## United States Patent and Trademark Office

## Advisory Action Before the Filing of an Appeal Brief

Application No.	Applicant(s)		
10/673,155	ICHIKAWA ET AL.		
Examiner	Art Unit		
Greg Binda	3679

## F I G. 1

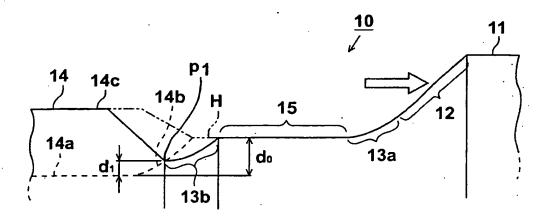
12. 🛚	Note the attached Information Disclosure Statement(s).	(PTO/SB/08 or PTO-14	l49) Paper No(s)		
13. 🛭	Other: A substitute specification is still needed. It is the	only way to correct the	directional errors made	de by applicant in the	<u> </u>
<u>amer</u>	ndment filed April 19, 2005. The replacement drawings file	ed August 16, 2005 are	the imaginary portion	of the line 14b is not	<u>ne</u> Ldraws
anv c	ction noted in item 3a of the final rejection. Applicant's rer differently in the replacement drawings than it was drawn i	nanks not withstanding, n the previously filed dr	awings.		<u>. urawil</u>
<u> </u>	and only in the replacement drawings than it was drawn i	providucij mod di	/ 10		
			Grea B	linda

Disproved 8-29-05

F I G. 3

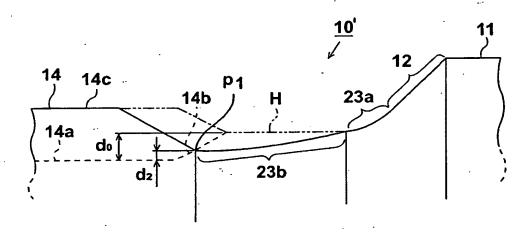
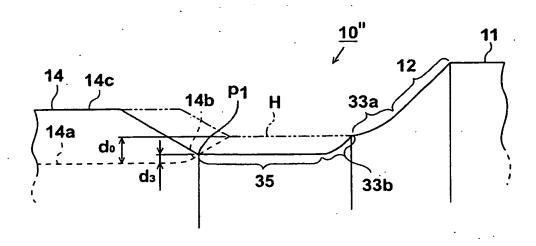
Dis approved
8,29.05

F I G. 5

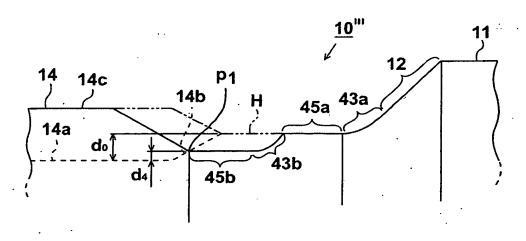
D. 29-05
